#### STATE OF TENNESSEE DEPARTMENT OF TRANSPORTATION

#### **INSTRUCTIONAL BULLETIN NO. 19-18**

#### Regarding Various Revised and New Standard Drawings.

**CLEAR** ZONE **CRITERIA**

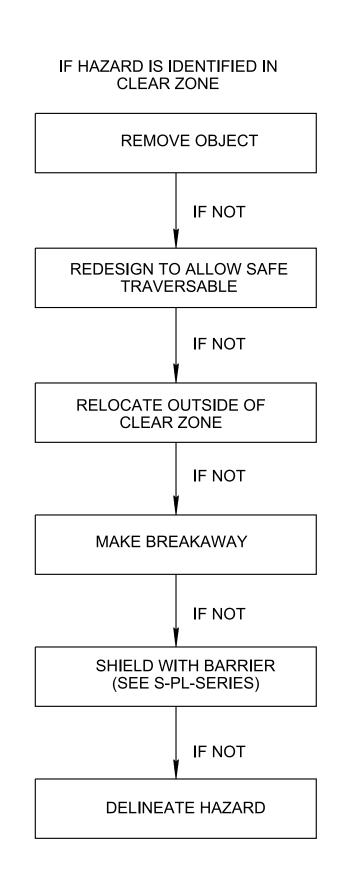
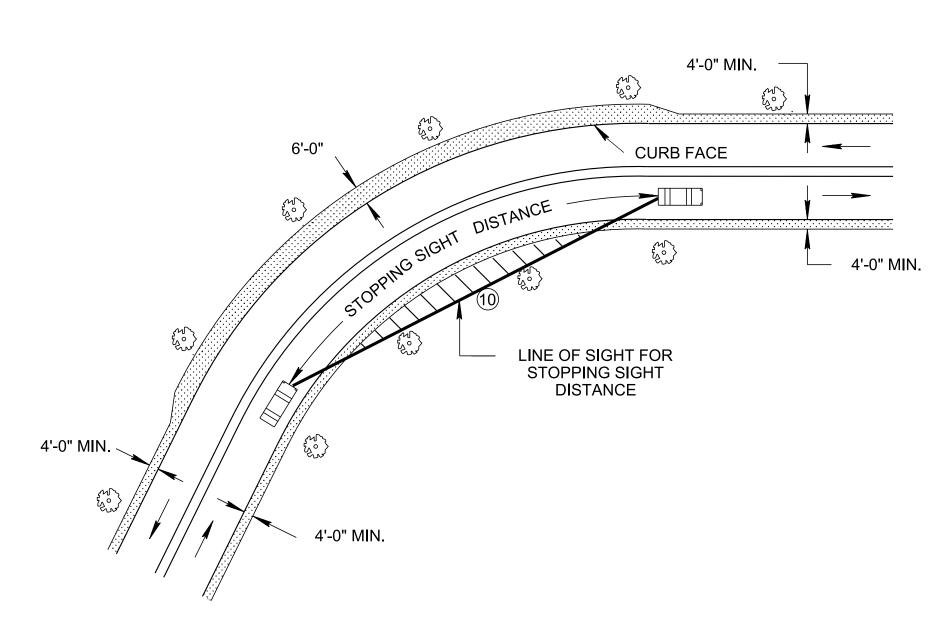
REV. 06-28-19: REVISED TABLE A AND B.

REDREW SHEET.

SAFETY PLAN **MINIMUM** INSTALLATION AT BRIDGE **ENDS**

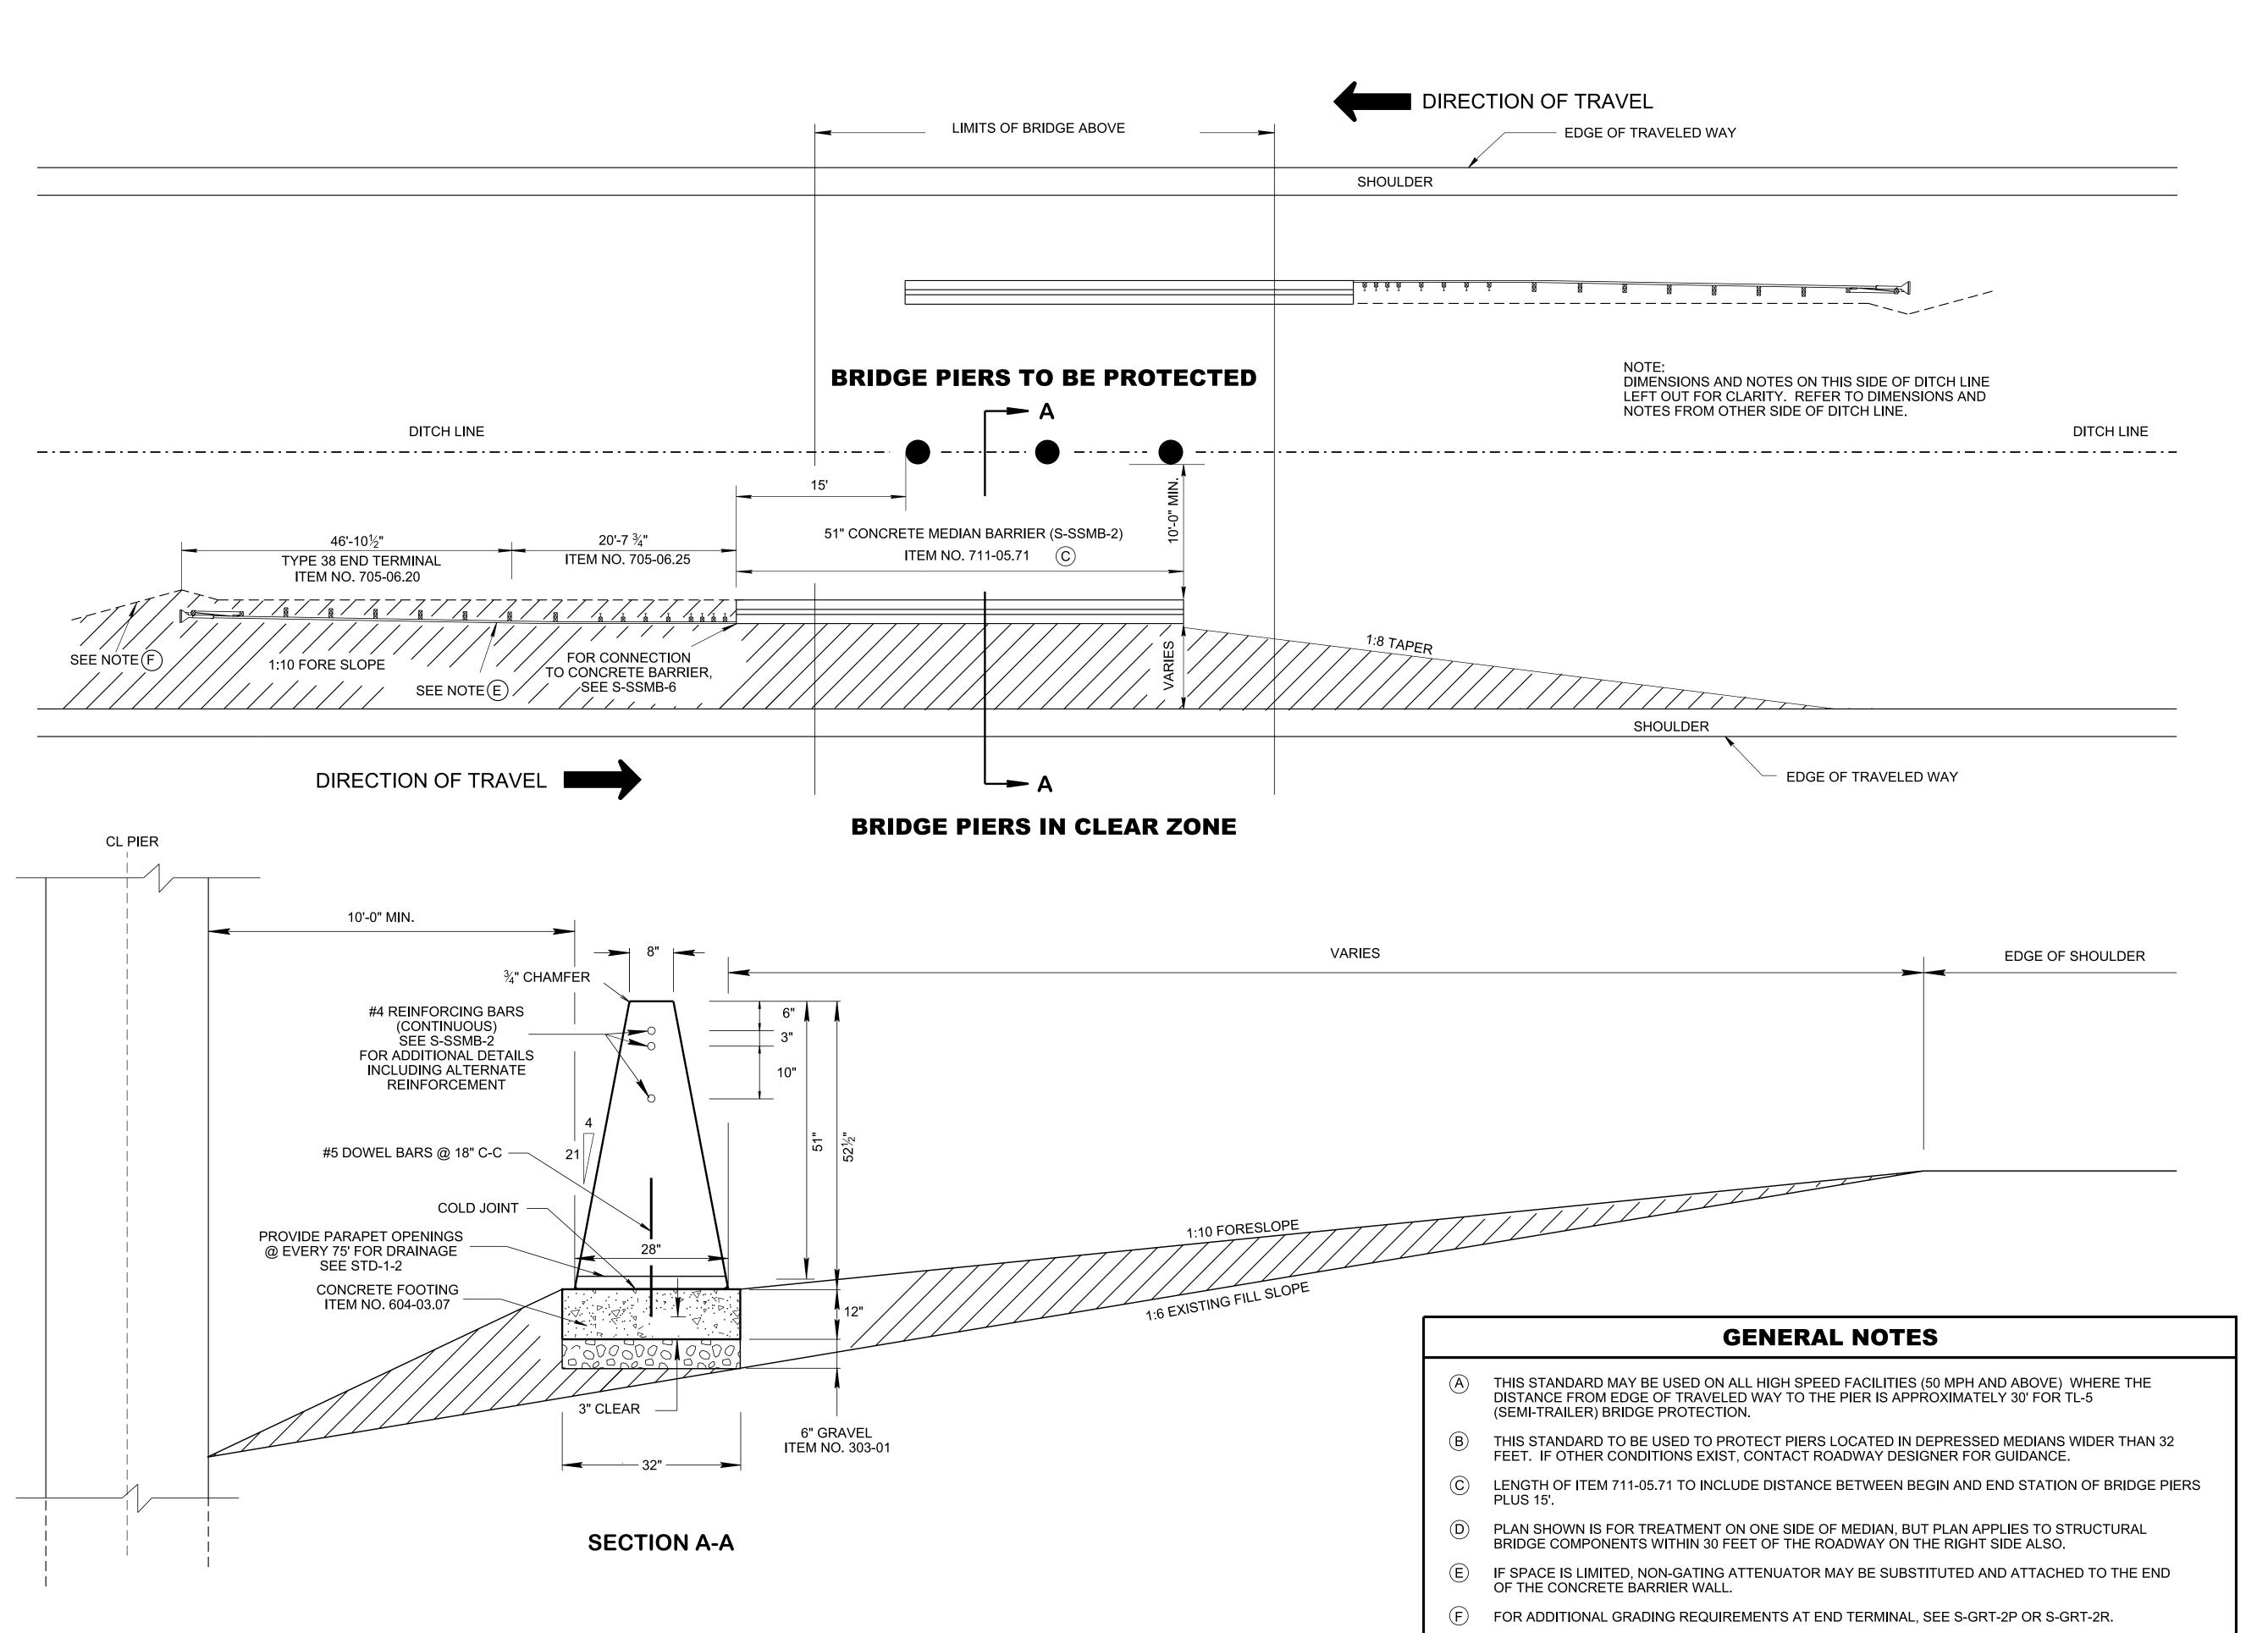
REV. 06-28-19: UPDATED TO MASH GUARDRAIL ITEM NUMBERS. REDREW

TERMINAL.

**UPDATED LENGTH OF TYPE 38 TERMINAL** AND MODIFIED PLAN VIEW FOR TYPE 38

SAFETY PLAN FOR BRIDGE PIERS IN CLEAR ZONE

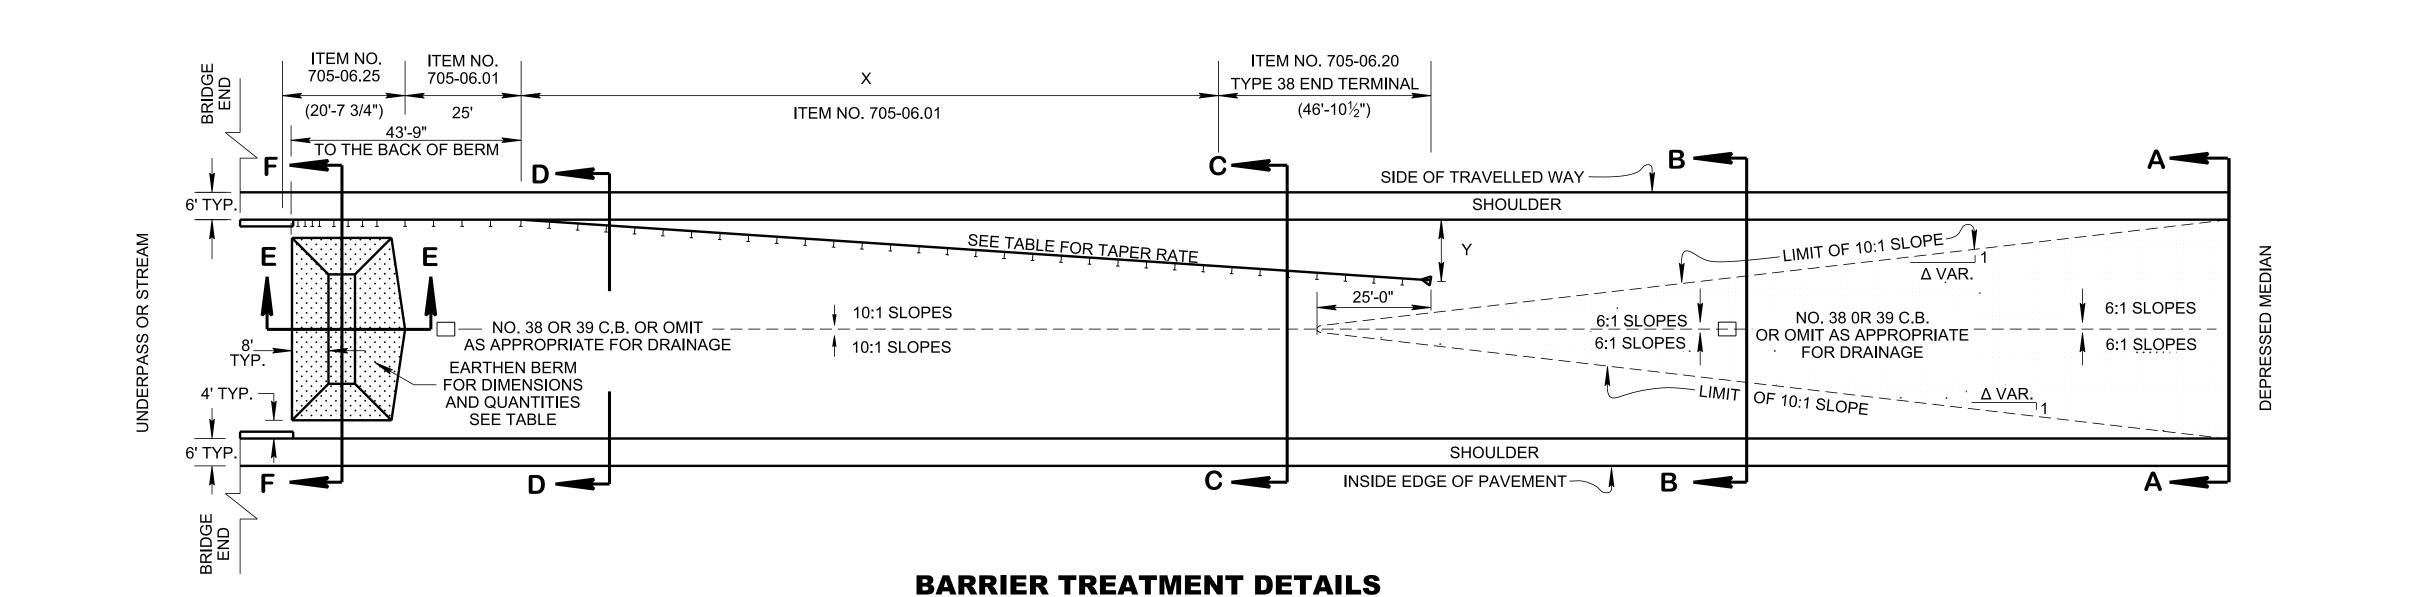
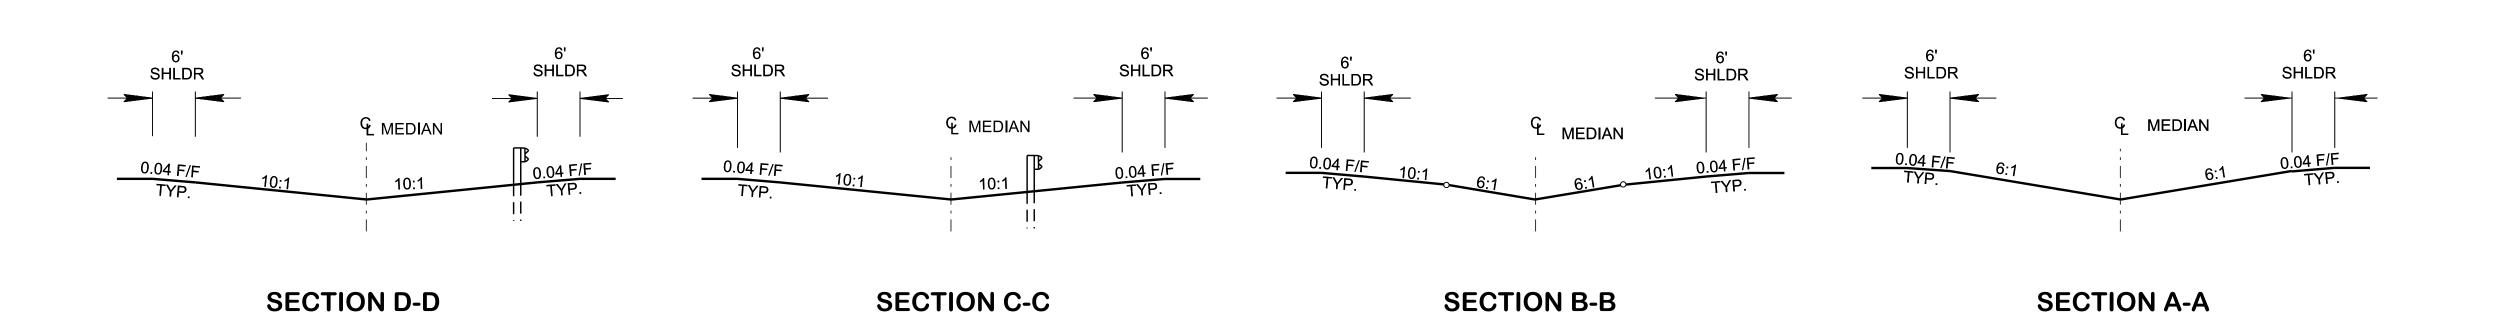
- REV. 4-11-14: CORRECTED CUT SECTION LABELS.
- REV. 10-10-16: UPDATED LENGTH OF TYPE 38 TERMINAL.
- REV. 06-28-19: UPDATED TO MASH GUARDRAIL ITEM NUMBERS. REDREW

**DETAILS OF** PAVEMENT MARKINGS FOR CONVENTIONAL ROADS AND MARKING **ABBREVIATIONS**

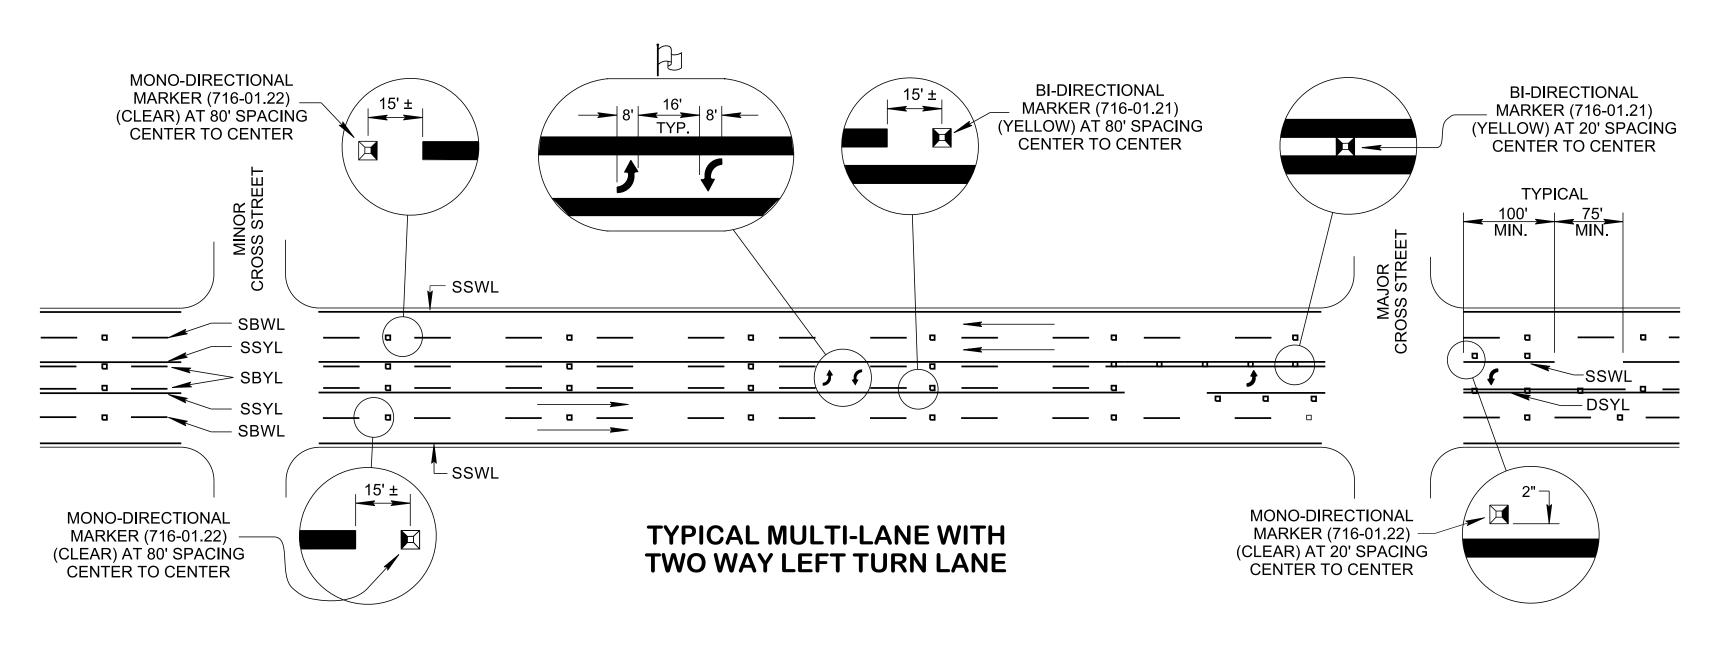
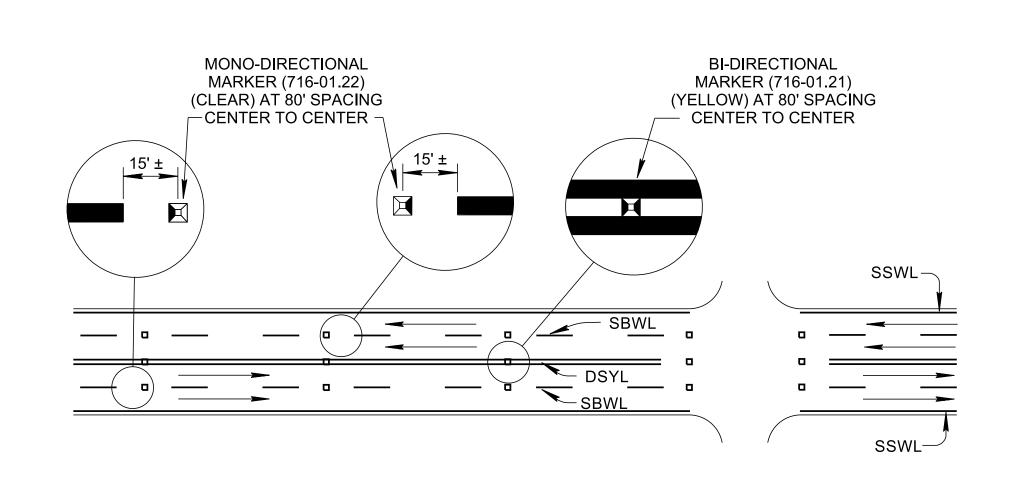
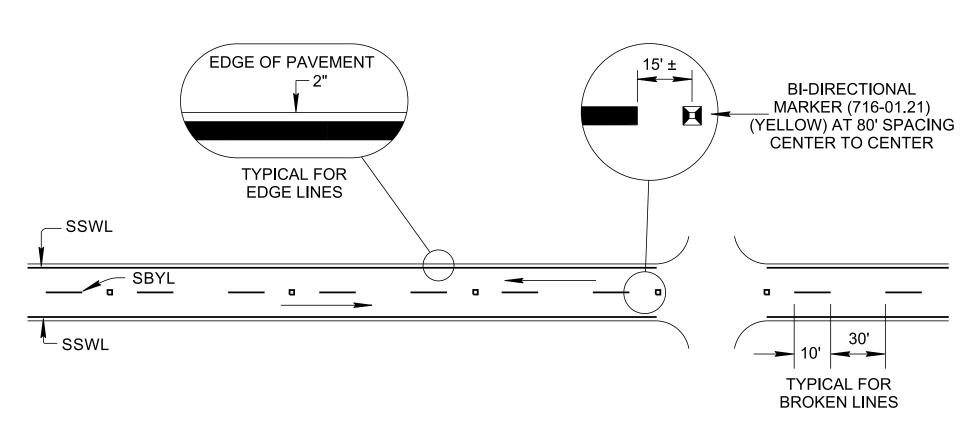
REV. 06-28-19: REVISED DETAIL INSETS. REMOVED PAVEMENT MARKING TABLE AND REDREW SHEET.

DETAILS OF PAVEMENT MARKINGS FOR CONVENTIONAL

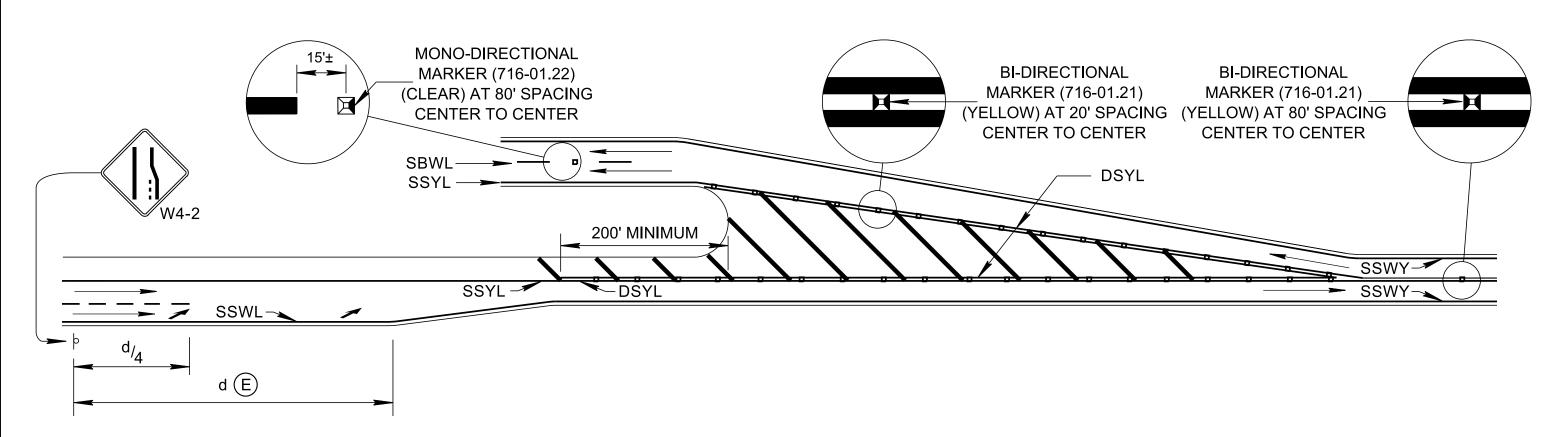
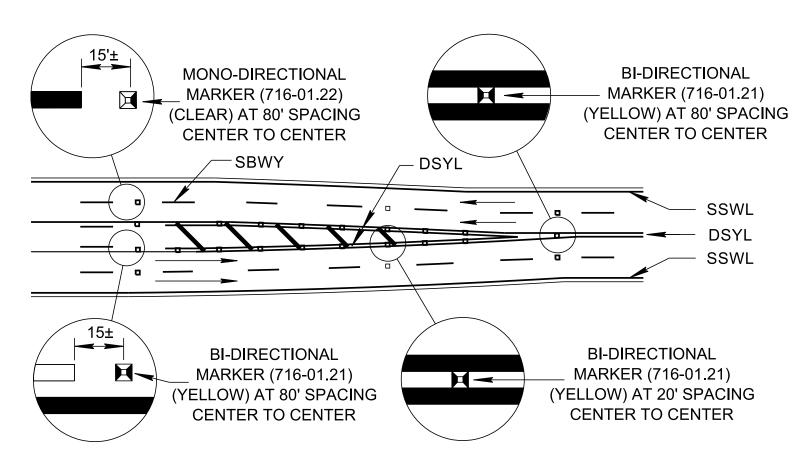
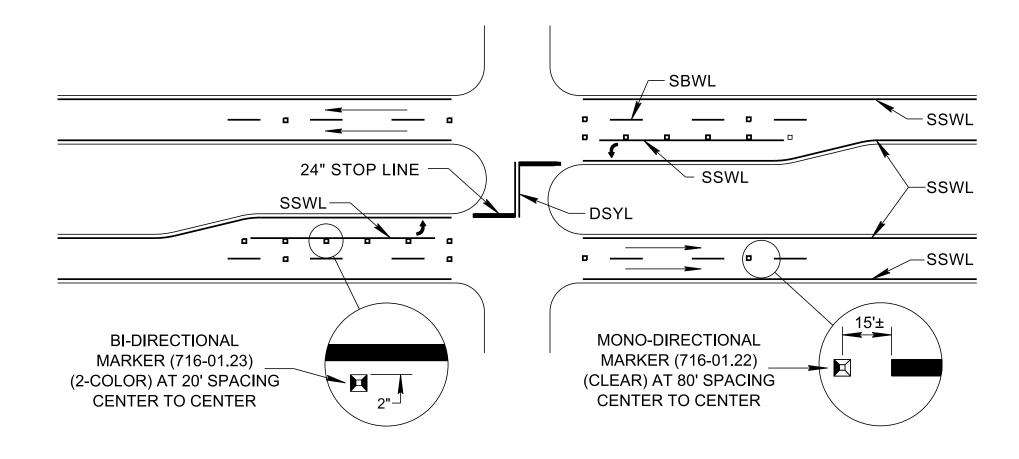
REV. 06-28-19: REMOVED PAVEMENT MARKING TABLE AND REDREW SHEET
